# Review of US EPA and USGS Groundwater Sampling Data Reports

## Pavillion, Wyoming

Prepared for  
Halliburton Energy Services, Inc.  
P. O. Box 42806  
Houston, TX 77242-2806

August 1, 2013

**Figure 1 Measurements of pH and TDS at MW01 Over the Course of Purging Approximately 1.5 Borehole Volumes**

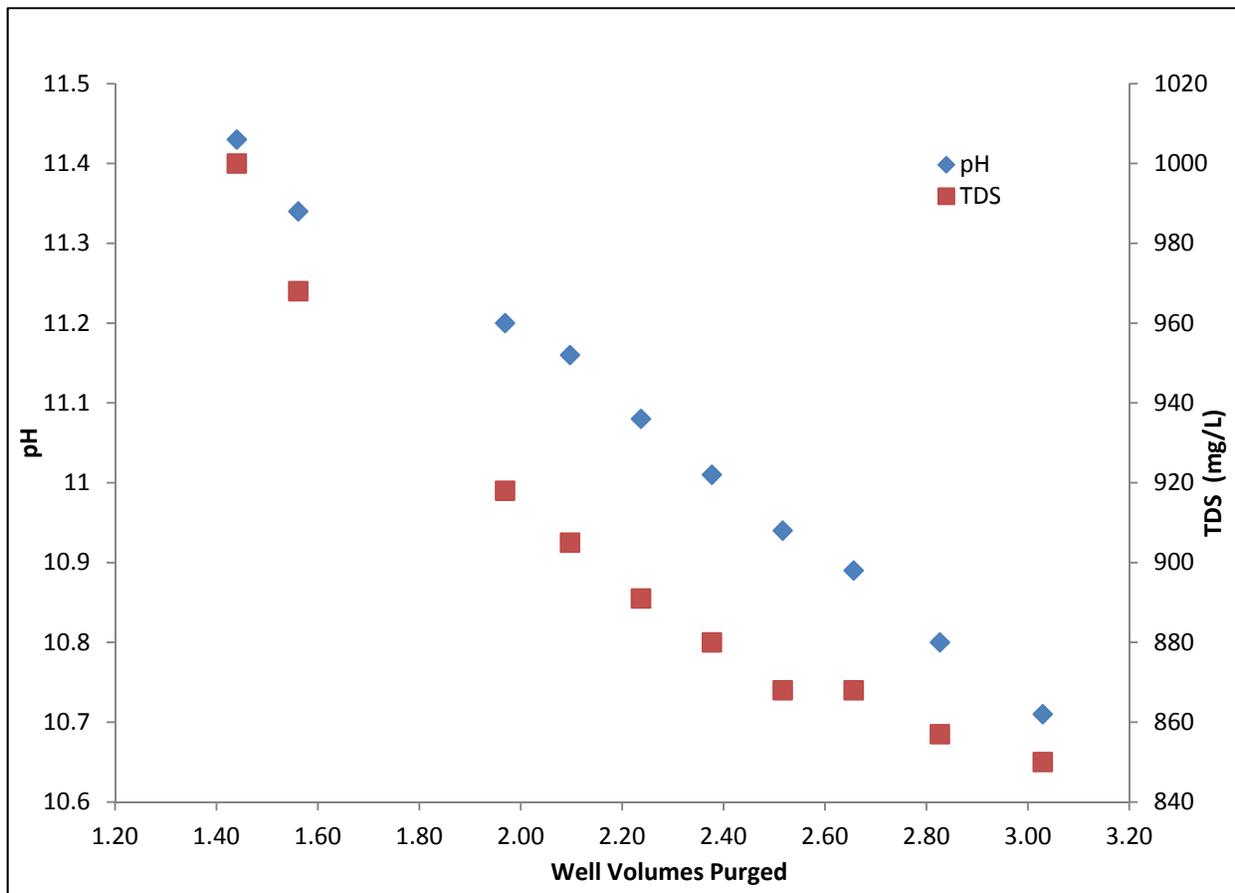
As part of the US EPA Phase V sampling at monitoring well MW01, up to 10 groundwater samples were collected for certain analytes; field parameters were also measured throughout the well-purging and sampling process. These data demonstrate that water quality changed over time during the sampling event. Gradual changes in water chemistry during purging are expected, due to the well drawing from an increasingly large portion of the aquifer as purge volume increases. These gradual changes reflect spatial gradients in groundwater chemistry<sup>5</sup> in the well's zone of influence and are distinct from rapid changes that occur as a result of contamination associated with well construction materials. Contamination due to well construction materials is localized to the vicinity of the well's screened interval, and therefore, purging several borehole volumes will typically reduce contaminant concentrations significantly.

In the case of MW-01, multiple samples taken during the purging process indicated a rapid change in water chemistry over the course of purging several borehole volumes, consistent with contamination due to well construction materials. Further, many of the constituents that changed rapidly are known to be associated with cement contamination (*e.g.*, pH, TDS, potassium). For example, pH declined from 11.4 to 10.7 over the course of purging and sample collection (Figure 1). Similarly, concentrations for total dissolved solids (TDS), an overall indicator of the total amount of dissolved constituents, also declined from approximately 1000 mg/l to 850 mg/l over the 1.5 borehole volumes purged between these samples (Figure 1). The magnitude of these changes in chemistry is large compared to the relatively small amount of water purged. These data indicate that water in the well and its immediate vicinity at the start of sample collection was in equilibrium with the cement grout, causing the initially elevated values of pH and TDS. These concentrations declined as fresh water from the formation flowed into the well and flushed out the cement-impacted water. This behavior is contrary to what would be expected if US EPA's assertion that the elevated pH and other inorganic analytes are attributable to HF fluid migration. If the

aquifer had been affected by HF fluids, the pH and concentrations of inorganic analytes would have remained stable and not declined temporally, as noted above.

Temporal Changes in  
Groundwater Quality at  
MW01 and MW02  
Pavillion, WY

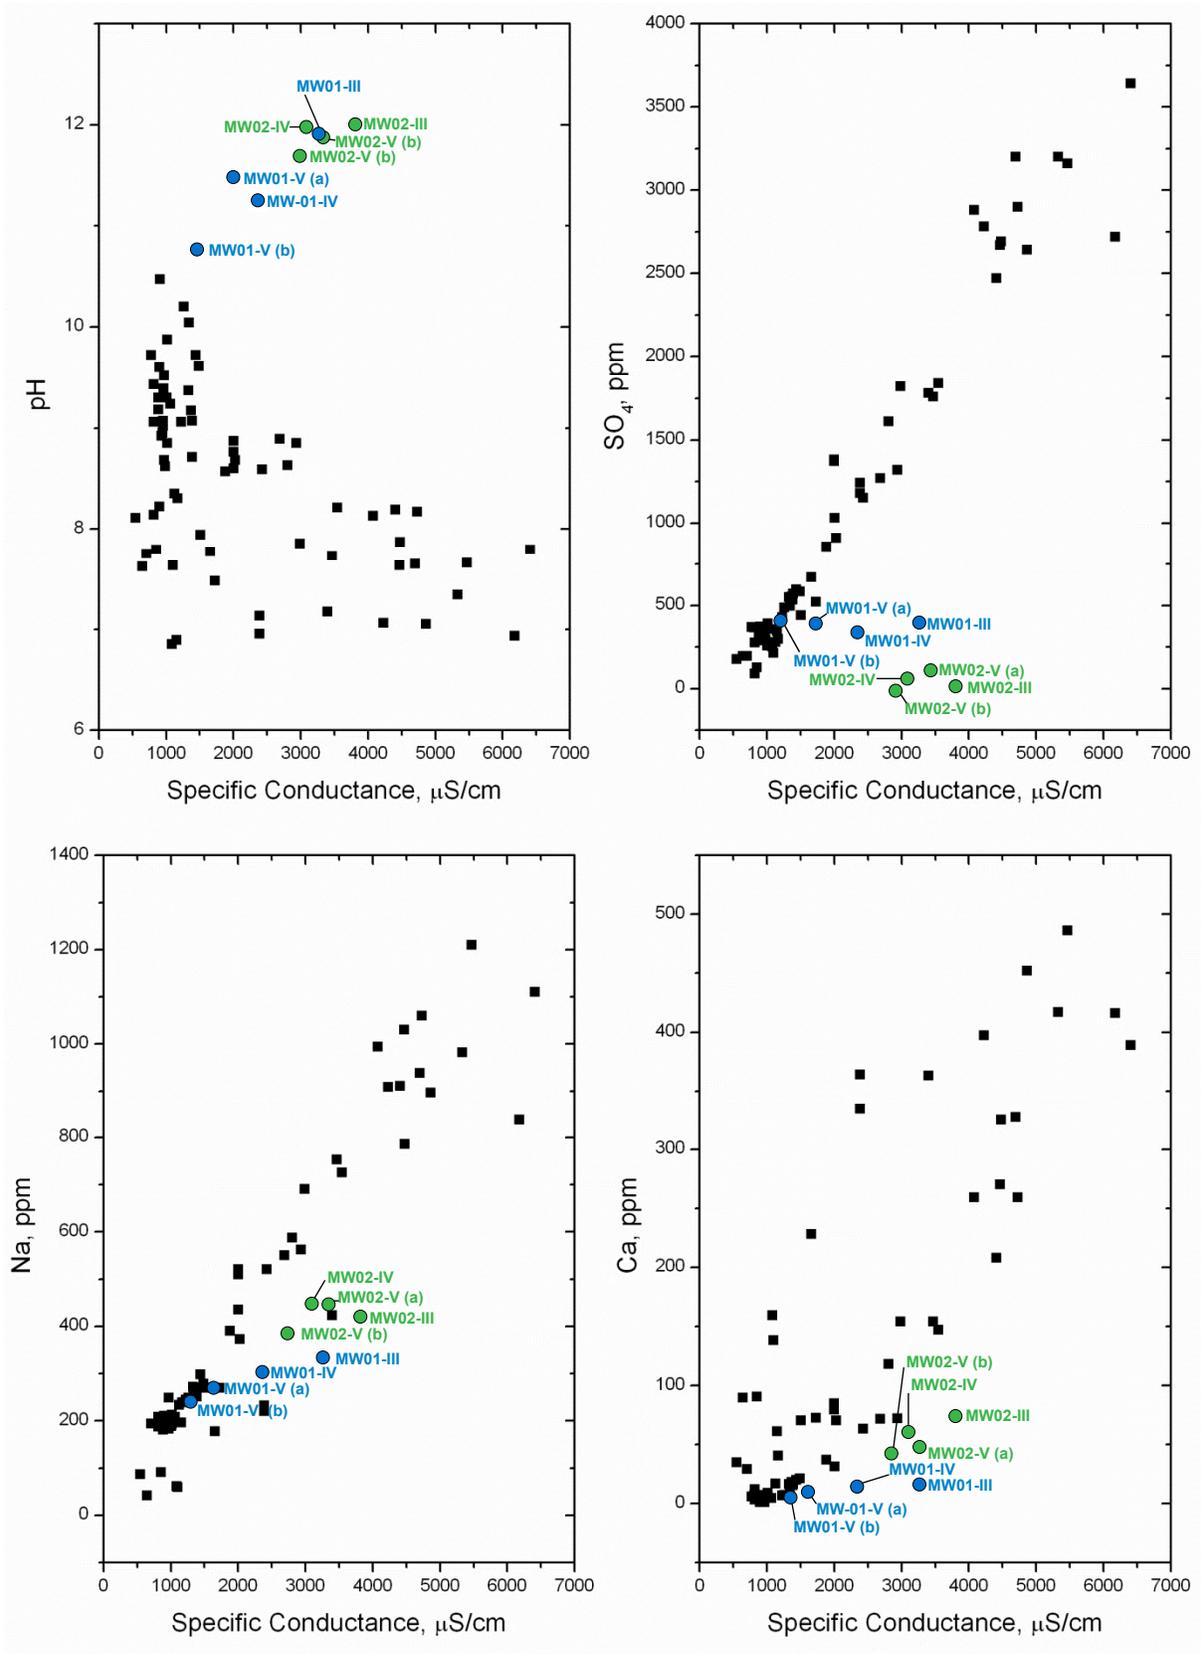
In its 2011 report, US EPA had also compared pH and concentrations of inorganic constituents at the deep monitoring wells to corresponding values recorded at private drinking water and stock wells. Based on these comparisons, US EPA concluded that the inorganic water chemistry at the deep monitoring wells was different from the other wells in the area and claimed that this was a result of contamination from HF fluids. However, as additional groundwater has been removed from the monitoring wells (*i.e.*, wells have been purged further), groundwater quality at the monitoring wells has changed and is now becoming similar to the water quality found at the other wells in the Pavillion region. As discussed above, this temporal change in water chemistry is indicative of cement contamination being gradually flushed from the vicinity of the wells as more water is purged. A reproduction of figures from the US EPA (2011) report modified to include the Phase V data clearly shows the temporal progression of groundwater data at the deep monitoring wells (Figure 2). There is an obvious trend in Figure 2 that shows groundwater chemistry at MW01 approaching the regional data set as water is purged during successive sampling events. The water chemistry at MW02 has also trended toward regional groundwater chemistry, but to a lesser degree, because the well is unable to produce a sufficient amount of water to adequately flush contamination caused by the poor well construction practices utilized by US EPA. It is anticipated that as additional water is removed from the monitoring wells, the groundwater chemistry will continue to change as localized effects of cement intrusion on water chemistry dissipate and groundwater quality at the deep monitoring wells becomes further consistent with regional groundwater quality. Overall, US EPA's assertion that elevated pH and other inorganic constituents were attributable to HF fluids has no technical basis.

Figure 3 Trend of Decreasing Concentrations of Glycols at MW01 as More Water is Purged from the Well

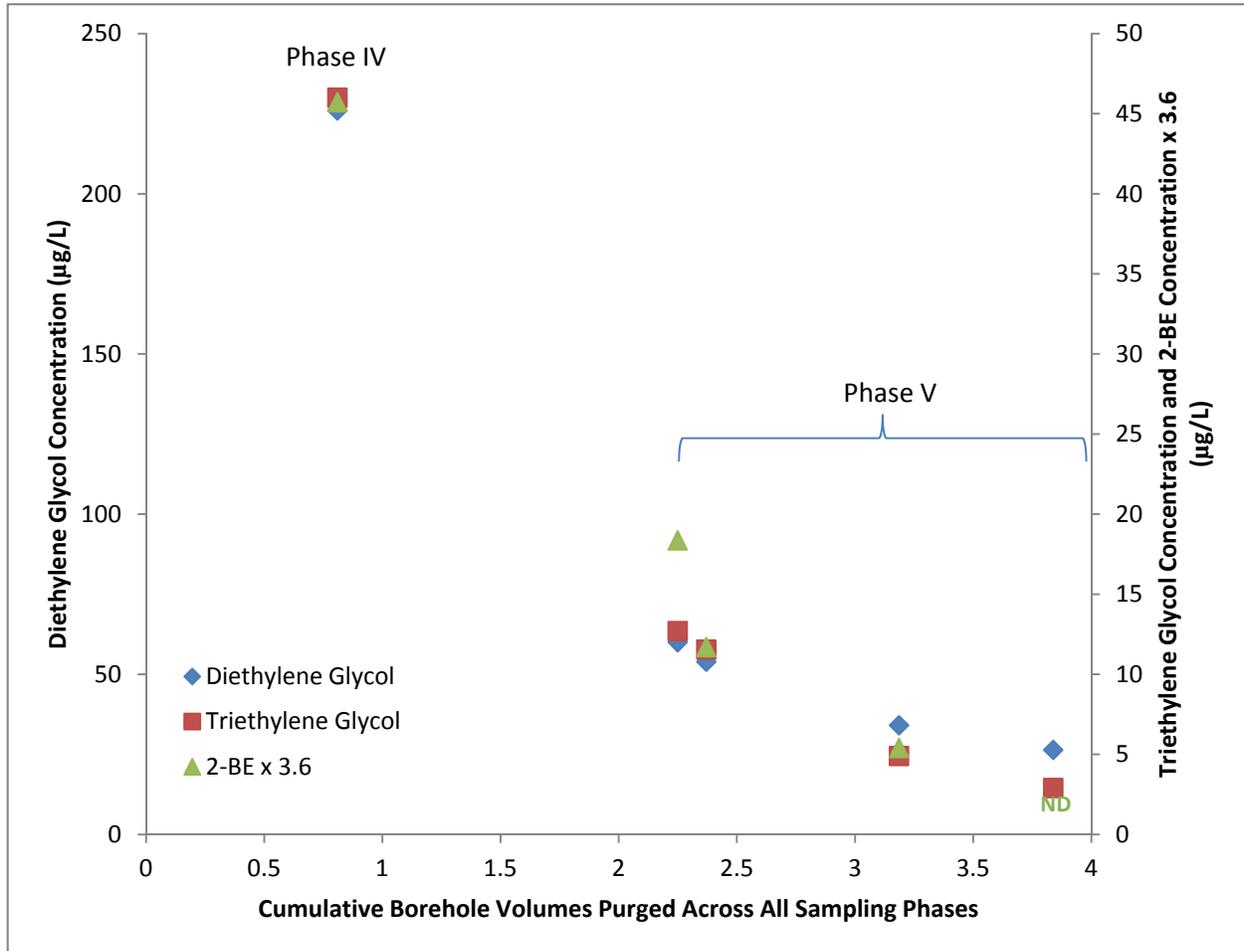
- There continue to be data quality concerns with regard to the analytical methods utilized by US EPA for the analysis of glycols (see Section 4). If the data are taken at face value, however, the glycol concentrations in groundwater are consistent with cement contamination and not hydraulic fracturing. Glycols are commonly used as grinding aids in cement production (Ervanne and Hakanen, 2007). If one assumes that the US EPA glycol data are not artifacts of the non-standard analytical methodology, the data collected by US EPA during the purging of MW-01 show a decreasing trend in glycol concentrations over time (Figure 3), consistent with near-wellbore cement-impacted water being gradually flushed from the vicinity of the well screen. The decreasing trend in glycol concentrations is consistent with decreasing concentrations of other cement-related constituents (*e.g.*, pH, potassium). These observations suggest that the potential presence of glycols, if not an artifact of non-standard analytical methods, is localized to the vicinity of the well screen and associated with contamination due to cement intrusion during well construction and not hydraulic fracturing.

- The same data quality concerns for glycols also apply to 2-BE because US EPA used the same analytical method for this chemical. If the 2-BE data are taken at face value, however, they are also consistent with contamination due to well construction materials and not hydraulic fracturing. During the course of purging MW01, the 2-BE concentrations declined almost identically to glycol concentrations and ultimately dropped below the detection limit at the end of purging (see Figure 3; the 2-BE datum below the detection limit is shown as a green "ND" in this figure). US EPA used carbon steel for the well casing with an unidentified black coating for its deep monitoring wells. These coatings often contain high concentrations of 2-BE (IARC, 2006). The pattern of declining 2-BE concentrations at MW01 is clearly indicative of contamination associated with well construction materials and not hydraulic fracturing.
